**RULE NO.: 161-23.05**

**NOTICE OF PROPOSED RULE**

**Standards Manual - Series 600 - Environmental**

661-4

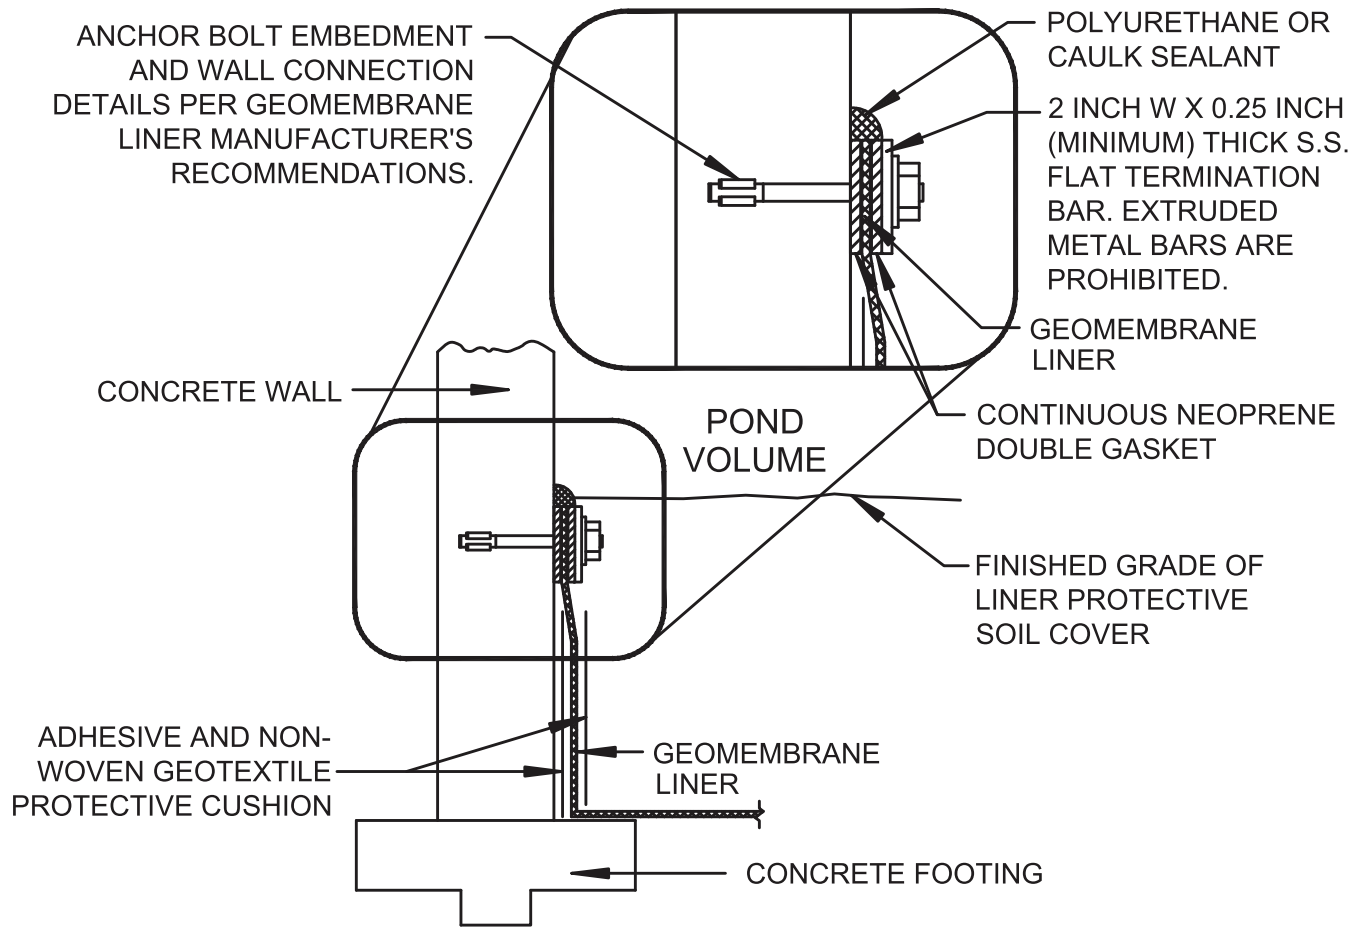
- Standard No. 661-4 – Geomembrane Liner Attachment Details: Removes this detail.
- Standard No. 661-4A – Concrete Wall Geomembrane Liner Attachment: Replaces 661-4 with an updated detail that incorporates acceptable methods for geomembrane liner attachment for placement under concrete walls.
- Standard No. 661-4B – Grouted or Mortared Stone Retaining Wall Geomembrane Liner: Replaces 661-4 with an updated detail that incorporates acceptable methods for geomembrane liner attachment for placement under grouted or mortared stone retaining walls.

REMOVE
